# TECHNICAL SERVICE BULLETIN

<b>ISSUE DATE:</b>	3-4-2021
<b>SERVICE BULLETIN SUBJECT:</b>	35 Foot 800 Volt ECAB VEC Label Retrofit
<b>VINs or MODELS AFFECTED:</b>	Service Specified Buses
<b>COMPLETE BY:</b>	Next Service Opportunity
<b>SERVICE BULLETIN #:</b>	SC-21-32
<b>Labor Operation Code:</b>	ED41Z

## **35 FOOT 800 VOLT ECAB VEC LABEL RETROFIT**

VEC Label

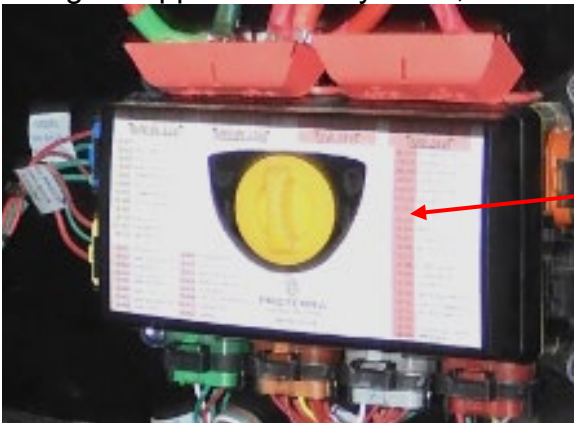
This procedure updates the ECAB VEC Label to the correct version.

3. Using an Approved Safety Knife, carefully remove the Label from the VEC.

4. Replace the label with the new Label (050128).
5. Using a T-30 Torx Driver, replace the ECAB Cover.
6. Remove the Lockout/Tagout devices and return the bus to service.
